Regulatory Correspondence between the NMED HWB and the Air Force Regarding the Letter Addendums to the LNAPL Containment Interim Measures Work Plan Part 1 – Characterization, Bulk Fuels Facility Spill, SWMUs ST-106 and SS-111

Subject: LNAPL Containment Well Location and Installation. LNAPL Containment Interim Measures Work Plan Part 1 – Characterization, Bulk Fuels Facility Spill, SWMUs ST-106 and SS-111, Addendum November 2011

Subject: **LNAPL Containment Well Location and Installation**
LNAPL Containment Interim Measures Work Plan Part I - Characterization, Bulk Fuels Facility Spill, Solid Waste Management Units ST-106 and SS-111
Addendum November 2011
Albuquerque, New Mexico

Re: Addendum to the Light Non-Aqueous Phase Liquid (LNAPL) Containment Interim Measure Work Plan, Part 1 – Characterization Plan, Bulk Fuels Facility Spill, SWMUs ST-106 and SS-111, November 2011, Kirtland Air Force Base, HWB-KAFB-10-037

FIGURE 1

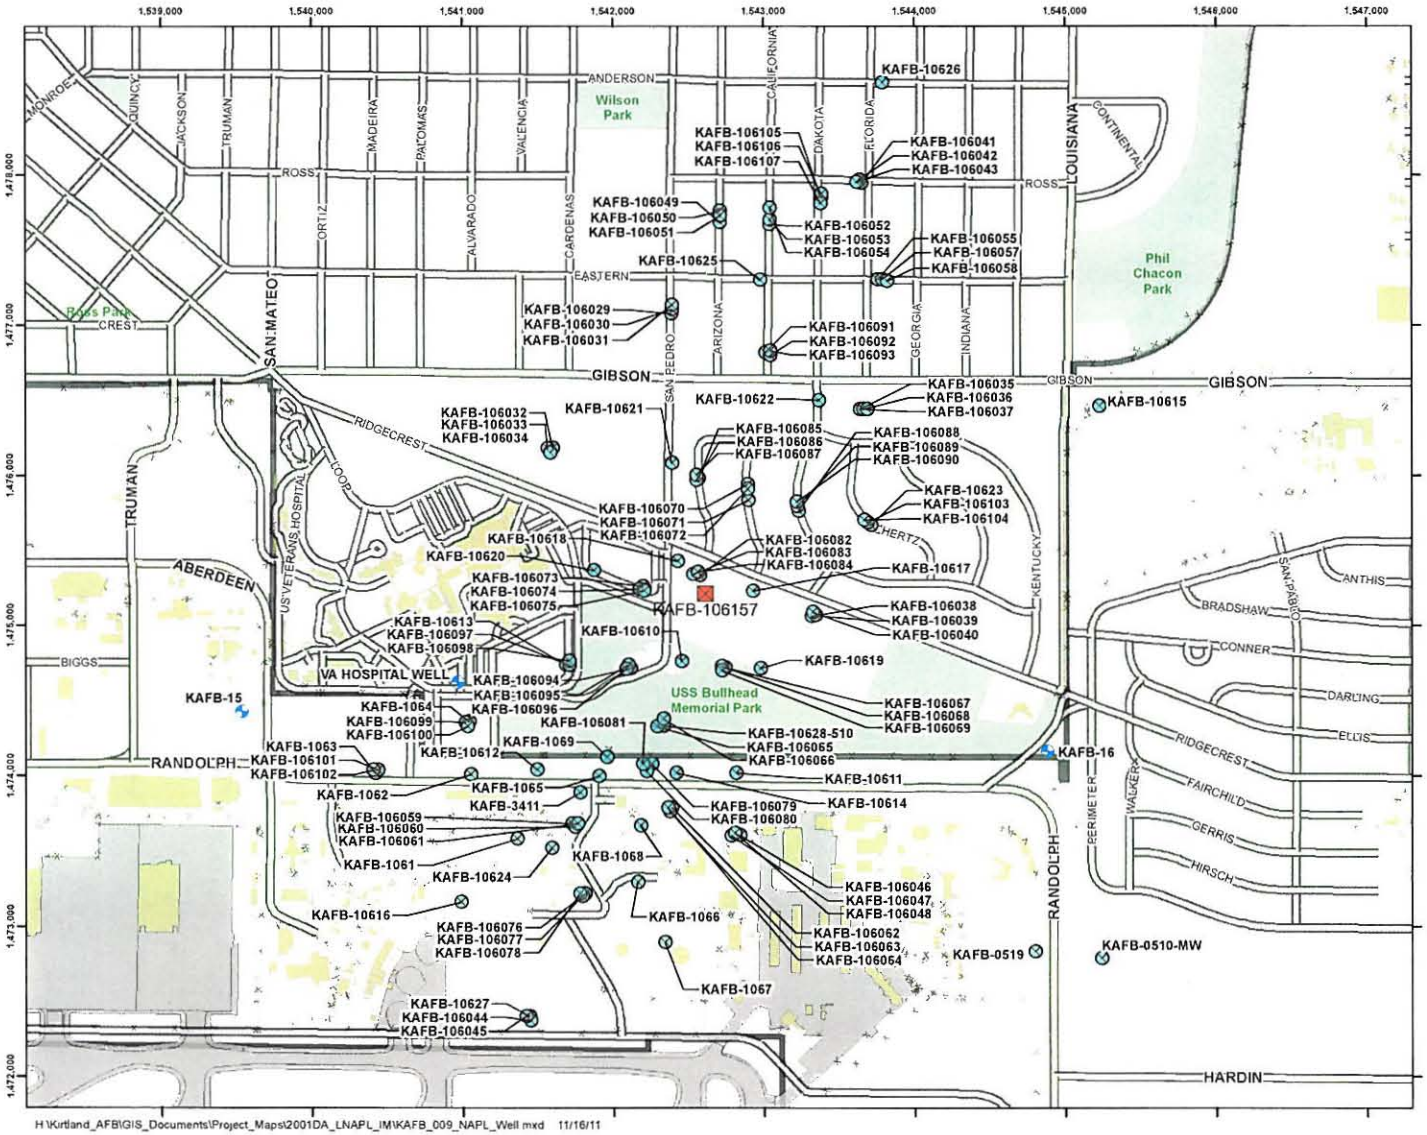
Shaw conducted a technical evaluation of the proposed containment well location and quantity as a result of discussing with the NMED Tiger Team on 3 November 2011. As a result of that evaluation, Shaw determined that a single containment well would be sufficient for containing the LNAPL, meeting the primary objective of the containment system and work plan. The proposed change is to move KAFB-106157 approximately 180 feet southeast of the original location (Figures 1 and 2). Figure 3 shows the predicted capture zone of this containment well, using the most recent hydrogeological data and recently acquired production well data for both Kirtland Air Force Base (AFB) wells and the Albuquerque Bernalillo County Water Utility Authority (ABCWUA) wells.

NMED approves the revisions pertaining to well design, location, installation, and borehole sampling of well KAFB-106157. The Permittee may proceed with the installation of well KAFB-106157.

NMED reserves the right that it may require that an additional extraction well be installed in the future to accomplish the goal of hydraulic containment. As indicated in NMED's letter of March 31, 2011, the capture of the LNAPL plume must be demonstrated with empirical data derived from water-level measurements showing the presence of a groundwater divide.

Figure 4. Extraction Well Construction

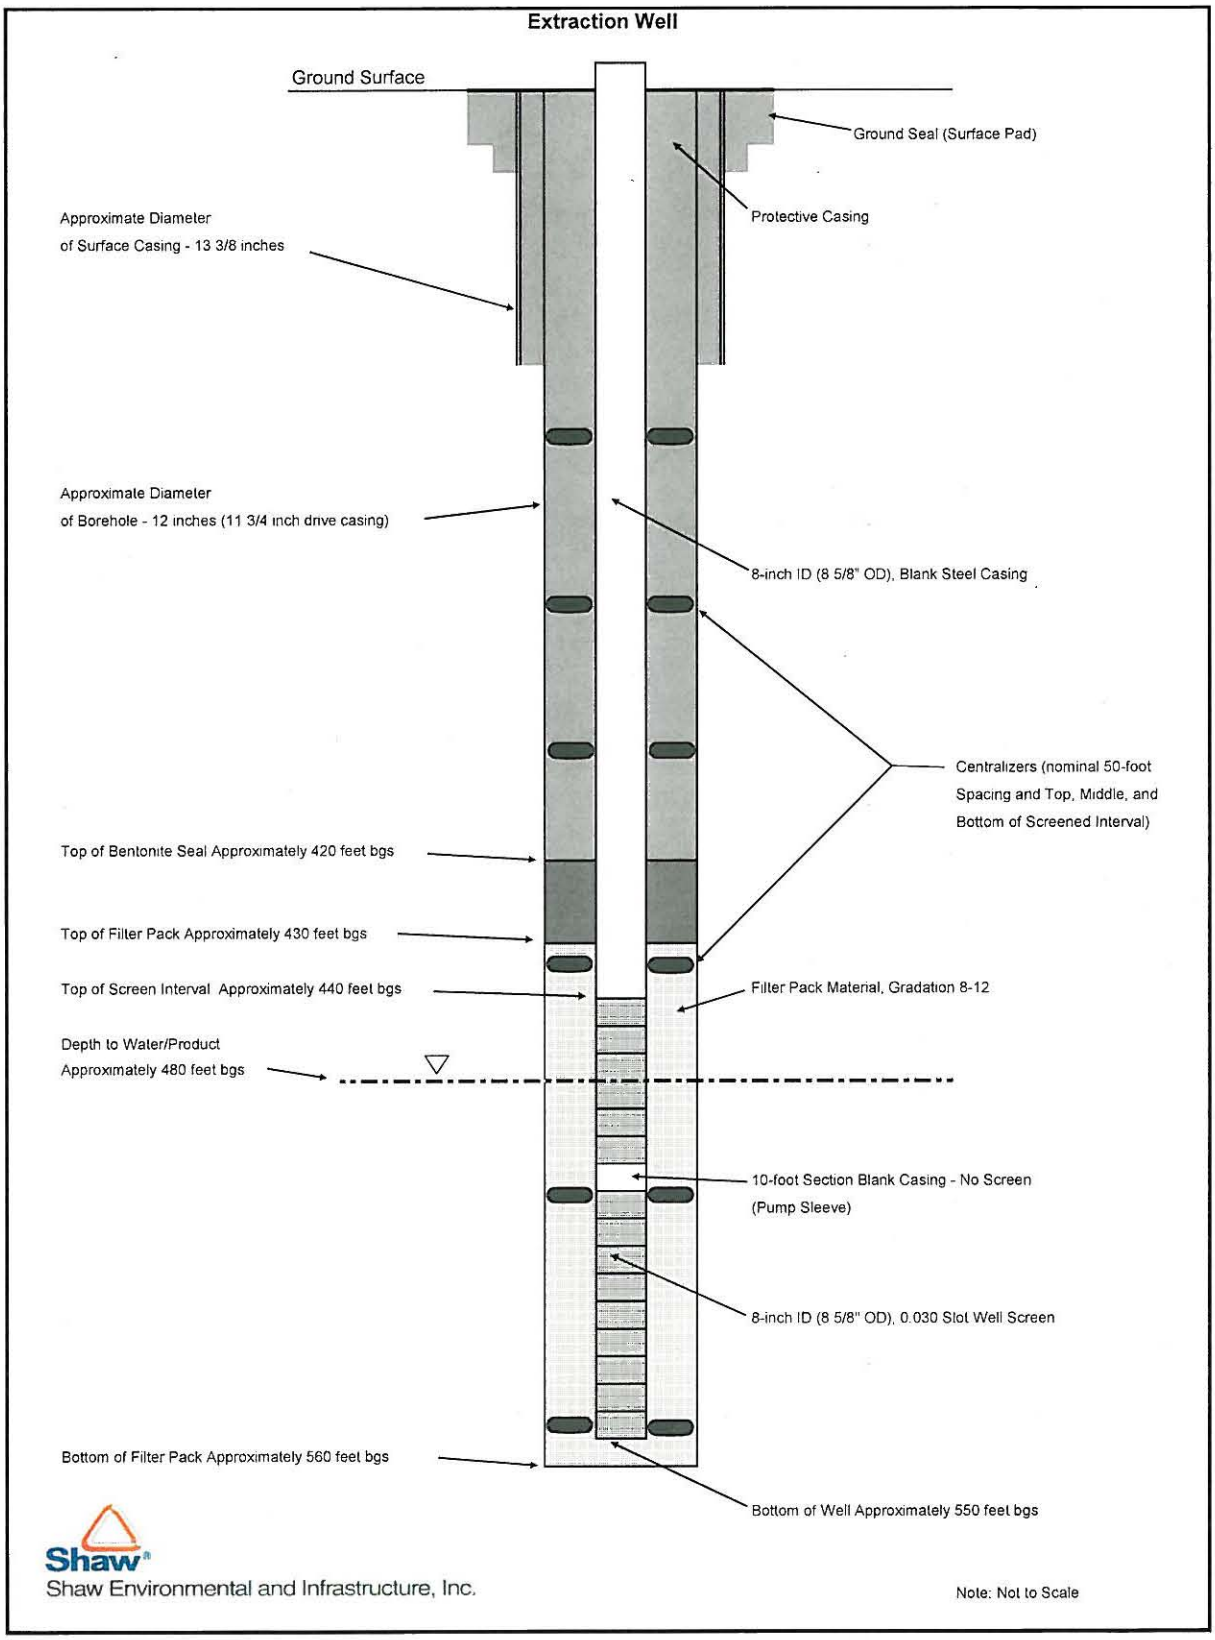
In order to accommodate the documented rise in water levels in the project area, the screening interval of the LNAPL containment well has been revised from what was proposed in the work plan. Figure 4 is a schematic diagram of the proposed well construction. Below is the proposed procedure and well design for the LNAPL containment well KAFB-106157:

- The well boring for the LNAPL containment well will be advanced using ARCH drilling method to approximately 60 feet below the water table. The well will be installed approximately 540 feet below grade at the well location.

- KAFB-106157 will be constructed with 90 feet of 8-inch diameter welded joint 0.030 slot stainless steel continuous wrap screen with double strong wires and rods, a 10-foot blank stainless steel pump sleeve section placed approximately 30 feet below the current water table, and a Schedule 40 carbon steel casing riser (Figure 2). The well will be constructed with 60 feet of screen/pump sleeve below the water table and 40 feet of screen above the water table to accommodate future water table rises. The steel well casing will extend approximately 2.5 feet above grade as a temporary completion during well development. The final depth of the pump sleeve will be decided in the field based on lithology encountered during drilling.

- An engineered 10-20 sand pack filter pack will be installed in the annular space between the well casing/screen and the borehole from the bottom of the borehole to approximately 10 foot above the top of the screened interval. The filter pack will be slurried with clean potable water and tremied into place to prevent bridging and to ensure continuous placement, while the drive casing is slowly removed. A 10-foot hydrated bentonite seal will be emplaced above the sand filter pack and incrementally hydrated with potable water in 1-foot lifts.

- After the last lift has hydrated for 2-hours, a cement grout with 6 percent bentonite and 2 percent calcium chloride by weight mixed at a weight density not less than 12.5 pounds per gallon will be

emplaced by tremie pipe to approximately 1.5 foot below the ground surface. The contractor will provide a mud balance and measure the grout weight density twice during placement to certify the grout specification.
